Access Compliance Report

Public Rights-of-Way

(Curb Ramps)

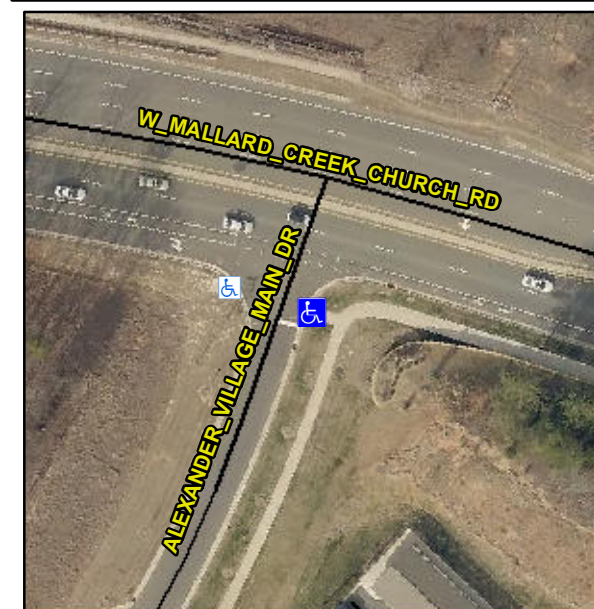
Intersection ID: 52608	Main Street: W_MALLARD_CREEK_CHURCH_RD	Cross Street: ALEXANDER_VILLAGE_MAIN_DR	Location: S
ADA ID: 5F92263B2194	Ramp Type: Perp	Initial Pass/Fail: Fail	Overall Compliance: No
Severity Score: 12.5			
Codes/Mitigation Info/Possible Solution		Field Measurements/Component Compliance

R304.2.2

Compliance	Description	Data	Compliance	Description	Data
N/A	Ramp Length (in)	97.0	No	Ramp Slope (%)	10.2
Yes	Ramp Width (in)	67.0	Yes	Ramp XSlope (%)	1.1
N/A	Flare Type LT	N/A	N/A	Flare Type RT	N/A
N/A	Flare Slope LT (%)	N/A	N/A	Flare Slope RT (%)	N/A
N/A	Flare Traversable LT?	N/A	N/A	Flare Traversable RT?	N/A
N/A	Landing Length (in)	N/A	N/A	DWS Provided?	N/A
N/A	Landing Width (in)	N/A	N/A	DWS Contrast?	N/A
N/A	Landing Slope (%)	N/A	N/A	DWS Length (in)	N/A
N/A	Landing X Slope (%)	N/A	N/A	DWS Full Width?	N/A
N/A	Landing Curb? (Y/N)	N/A	N/A	DWS Offset (in)	N/A
N/A	Shared Landing?	N/A			
N/A	Gutter Ponding?	N/A	N/A	Gutter Slope (%)	N/A
N/A	Gutter Lip Ht (in)	N/A	N/A	Gutter X Slope (%)	N/A
N/A	Painted X Walk1?	No	N/A	Painted X Walk2?	N/A
	X Walk 1 Direction	To NW		X Walk 2 Direction	N/A
N/A	X Walk 1 Width (in)	N/A	N/A	X Walk 2 Width (in)	N/A
	X Walk 1 Slope (%)	2.3		X Walk 2 Slope (%)	N/A
	X Walk 1 X Slope (%)	0.8		X Walk 2 X Slope (%)	N/A

Remove & Replace Entire Ramp.
